Informal document GRSP-56-39
(56th GRSP, 9-12 December 2014,
agenda item 3(a))

Proposal of amendments to ECE/TRANS/WP.29/GRSP/2014/30

Proposal for amendments to global technical regulation No. 9 (Pedestrian safety)

**Submitted by the expert from the European Commission as Chair of
the Task Force on Bumper Test Area within the Informal Working
Group on global technical regulation No. 9 Phase 2***

"Figure 5A

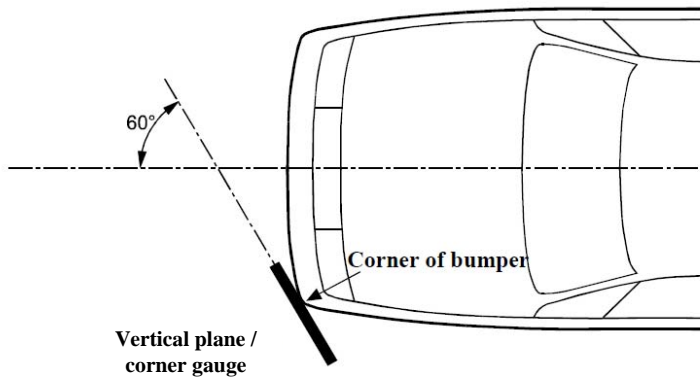
Figure 5, amend to read:

Corner of bumper example (see paragraph 3.14., note that the corner gauge is to be moved in vertical and horizontal directions to enable contact with the outer contour/
front fascia of the vehicle)

"3.14. "Corner of bumper" means the transversal position of the vehicle's point of contact with a vertical plane which makes an angle of 60° with the vertical longitudinal plane of the vehicle and is tangential to the outer surface of the bumper (see Figure 5). corner gauge as defined in Figure 5B.

The corners of bumper on both sides are subsequently defined as the outermost points of contact of the gauge with the outer contour/front fascia of the vehicle as determined in accordance with this procedure. Any points of contact on the top and the bottom edges of the gauge are not taken into account. The rear and side view mirrors and the tyres shall not be considered."

Figure 5B
Corner gauge

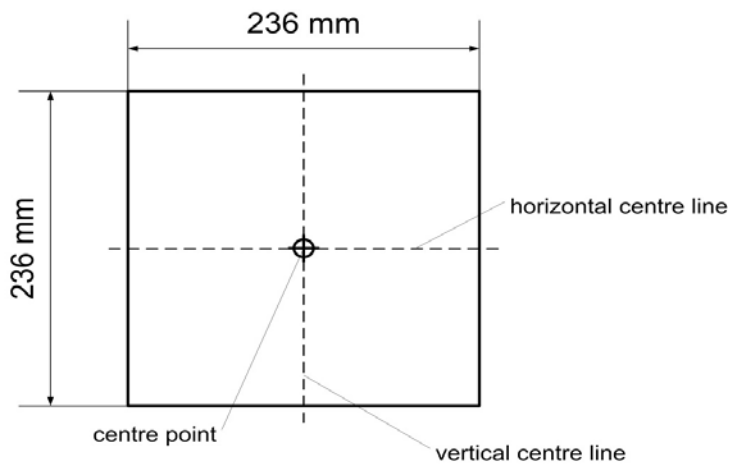
The front surface of the corner gauge is flat.

The centre point is the intersection of the vertical and horizontal centre lines on the front surface.

Figure 5C
Determination of the corner of bumper with the corner gauge (shown in random location)

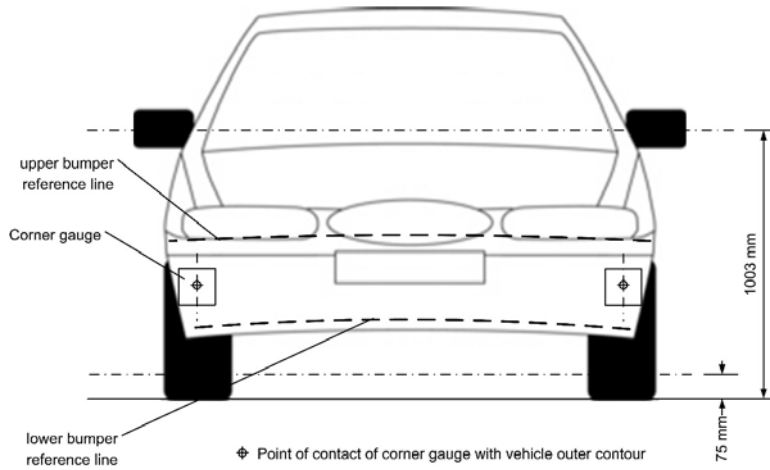
For determination of the corner of bumper, the front surface of the corner gauge is moved parallel to a vertical plane with an angle of 60° to the vertical longitudinal centre plane of the vehicle (see Figures 5A and 5C) at any height of the centre point of the corner gauge between:

For determination of the corner of bumper, the gauge is moved to contact the outer contour/front fascia of the vehicle touching at the vertical centre line of the gauge. The horizontal centre line of the gauge is kept parallel to the ground plane.

Figure 5D
Determination of bumper test area (note that the corner gauges are to be moved in vertical and horizontal directions to enable contact with the outer contour/front fascia of the vehicle)

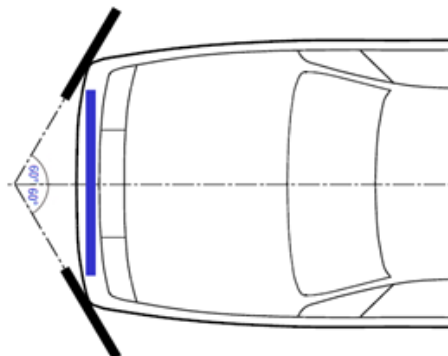
"3.11. "Bumper test area" means the frontal surface of the bumper limited by two longitudinal vertical planes intersecting the corners of the bumper and moved 66 mm parallel and inboard of the corners of the bumpers. either the front vehicle fascia between the left and right corner of bumper as defined in paragraph 3.14., minus the areas covered by the distance of 42 mm inboard of each corner of bumper, with this distance to be set from the most outboard point with a flexible tape held tautly along the outer surface of the vehicle, or the outermost ends of the bumper beam as defined in paragraph 3.9. (see Figure 5D), whichever area is wider."

6. During testing injurious points have been found outside test areas defined by measurements depending on the outer contour, especially at the ends of the bumper beam. As procedures based on the outer vehicle contour do not necessarily include the relevant injurious vehicle structures (e.g. bumper beam), at least the entire bumper beam should be included within the test area.

7. A clearer definition of what the bumper beam is provided by the Research Council for Automobile Repairs (RCAR).
 8. The margin zone of half the width of the legform is needed to ensure stable measurement results on angled surfaces. As the bumper beam method is not linked to external fascia and its position/angle, the margin zone is not applied for the latter.
